Proposed Modifications to Previously Approved Scheme Reg. Ref SD20A/0283.

Project Title: DUB 14/15 Proposed Modifications to Previously Approved Scheme SDA\0283

Drawing Title: Overall Site Plan Proposed

Scale at A0: As indicated	By / Chkd / Appd: SLIMMIRA
Role: Architecture	
Status: S2 - Suitable for Information - Planning -	
Arup Job No: 279225	Rev: P02
ID: A1010

1 Overall Site Plan- Proposed
1 : 2000

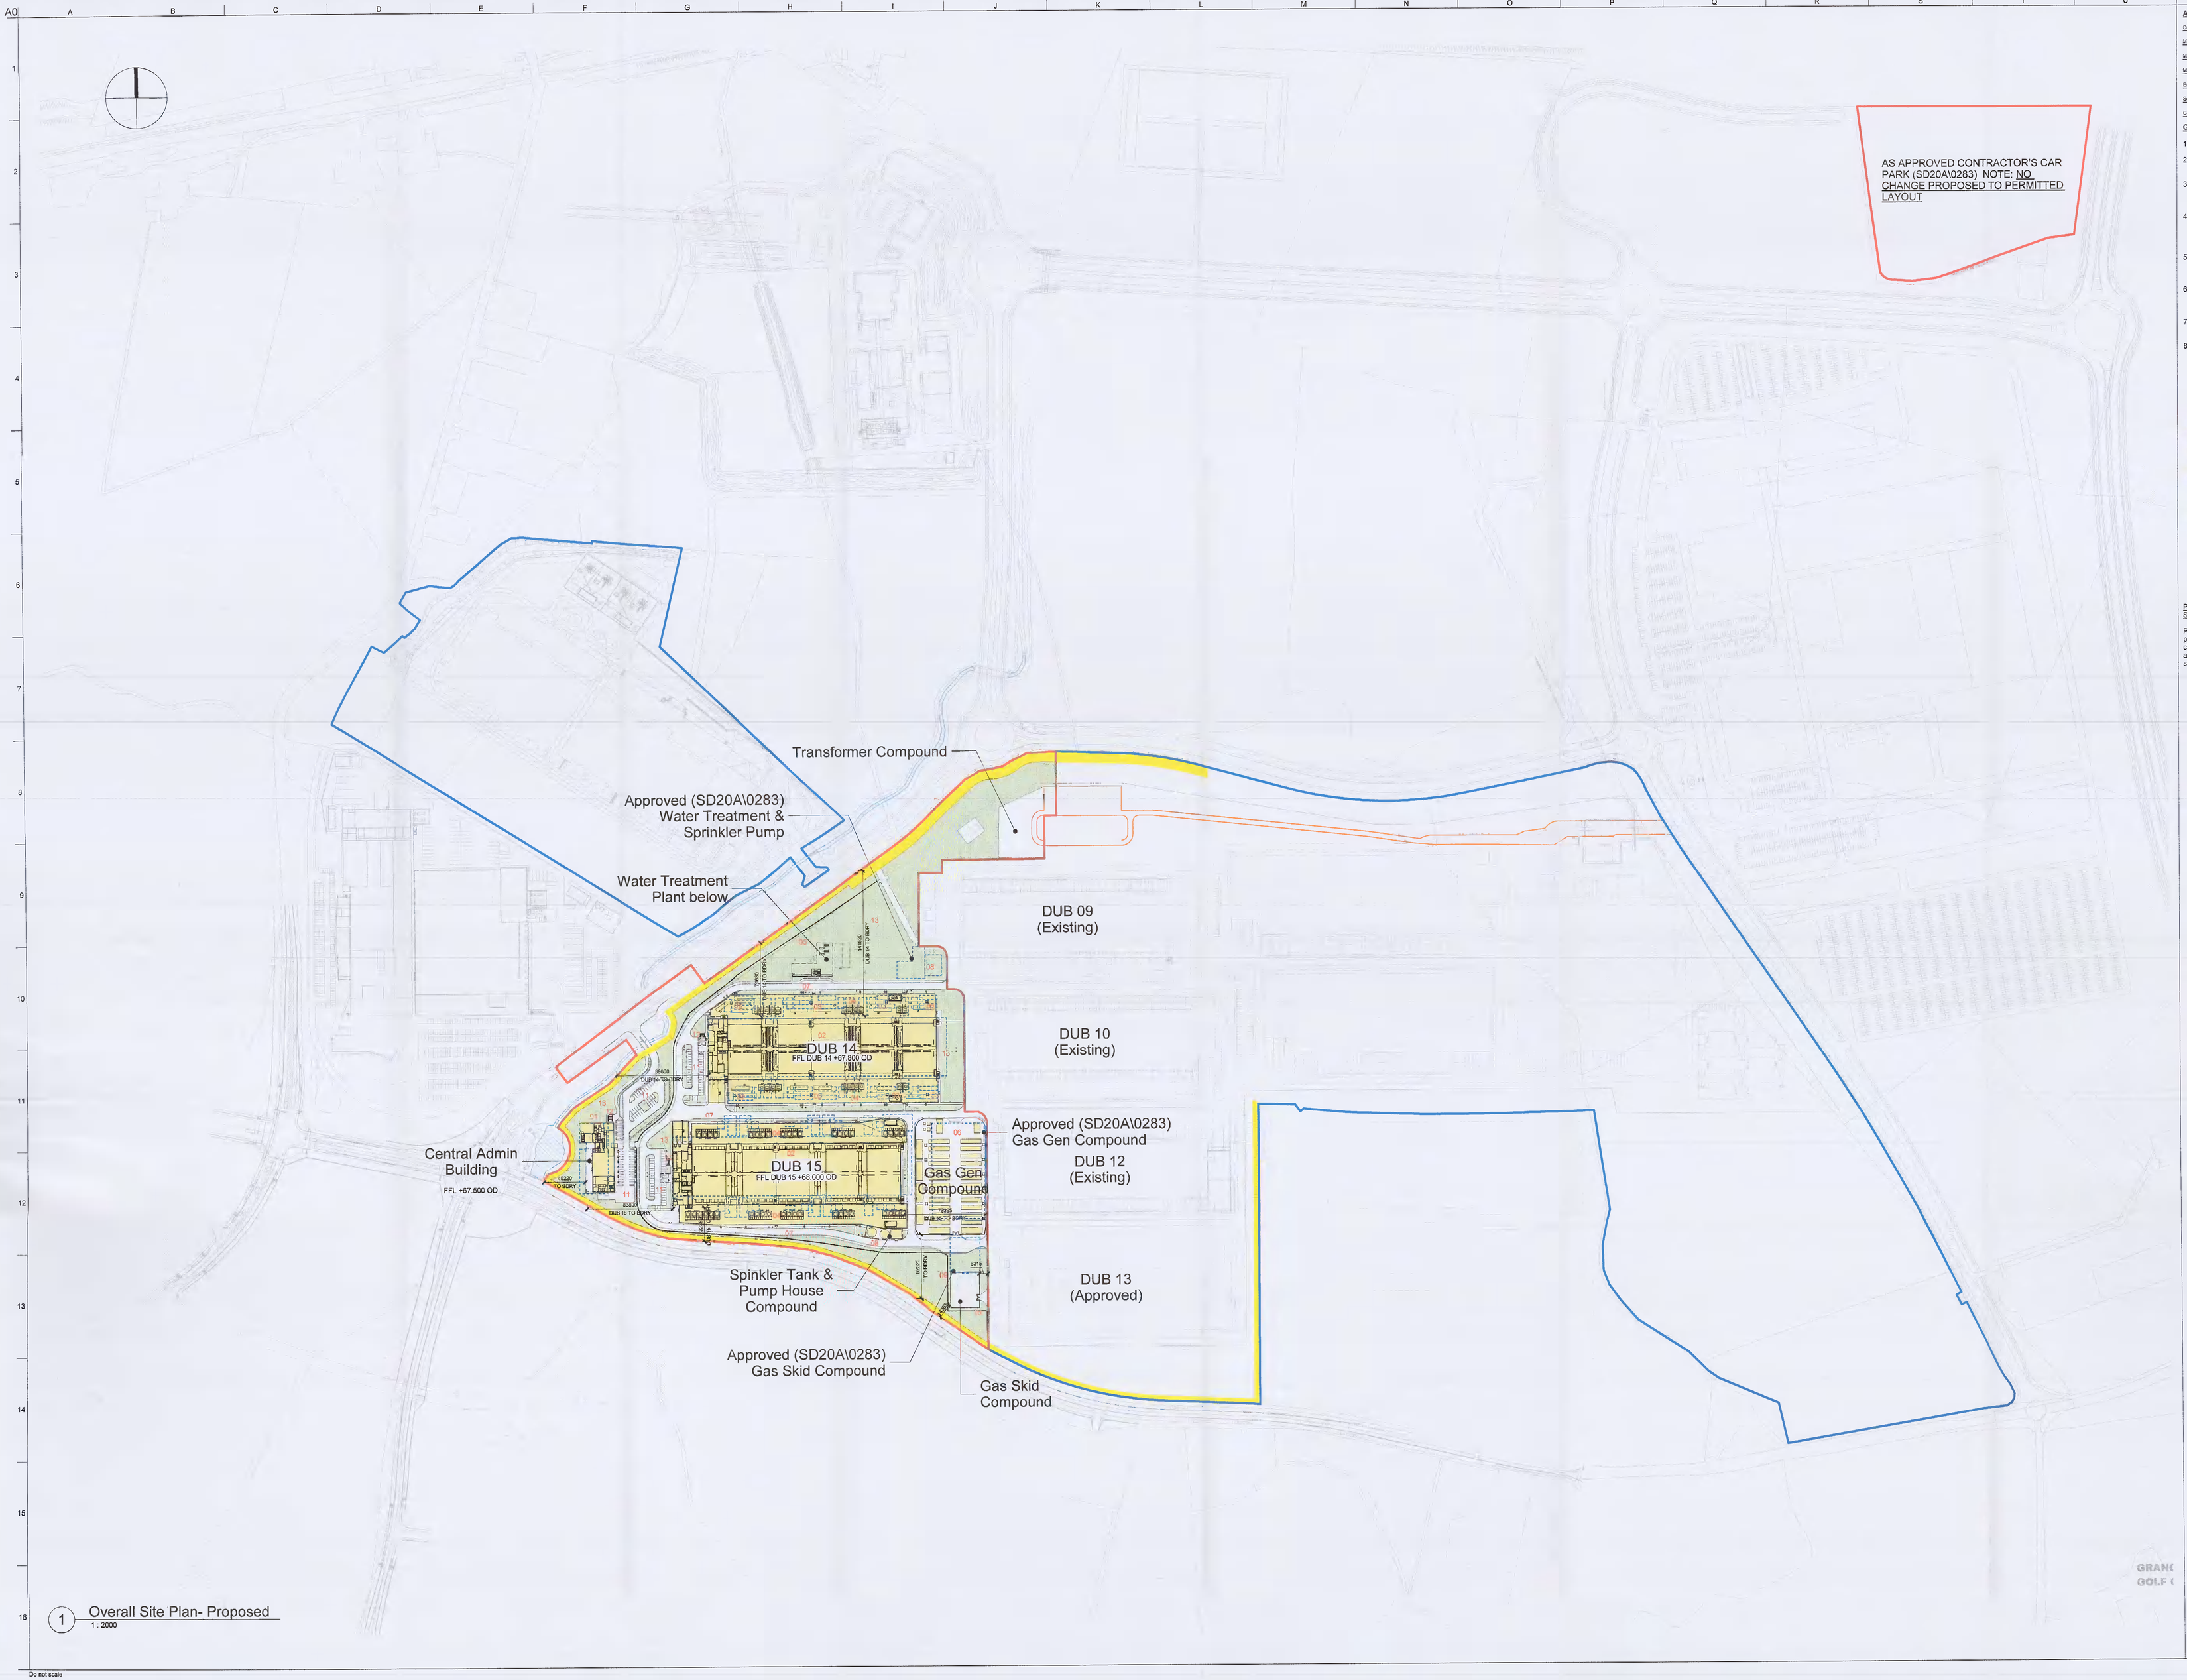
1 1.Approved Central Administration Building (CAB):
a. Building moved to the east by approx. 7m.
b. Increase of building footprint by approx. 170m2 (from 1,424m2 to 1,594m2)
c. Design development - changes to building layouts & elevations (design and finishes).
d. Approved four-storey Office element: Parapet at roof level to be raised by approx. 1.85m.

2 2.Approved Data Centres – DUB14 and DUB15:
a. Reconfiguration of building footprints & reduction in area of approx. 45m2
b. Design development - changes to building layouts & elevations (design and finishes)
c. Omission of zone of sedum roof finish.

3 DUB 14: Reduction in height of approved flues by approx. 650mm.

4 Reconfiguration of associated external plant at ground level (including generators / E-houses & transformers) flues, modification to design of screening to generator yards, omission of approved Modular Electrical Rooms (MERs) serving approved Data Centres DUB14 & 15

5 Relocation below ground, modifications to design and expansion of approved Water Treatment Building and associated plant.

6 Gas Generator Compound – Relocation & reconfiguration of previously approved gas generator compound including an additional flue.

7 Modifications to approved layout of internal site roads, yards and footpaths

8 Approved Sprinkler Tanks and Pump House for DUB14 relocated on existing site
DUB15 Sprinkler Tanks and Pump House relocated south of DUB15

9 Relocation of Approved Gas Networks Ireland (GNI) gas skid & compound including approved 3 no. kiosk buildings.

10 Proposed new vehicular access to serve revised GNI location off the existing Data Centre Compound

11 Modifications to approved car park layouts and landscaping design

12 Modifications to location and design of approved bicycle shelters.

13 Modifications to site development works, including underground water and building services provision, landscaping, internal security and compound enclosure fencing, and associated works
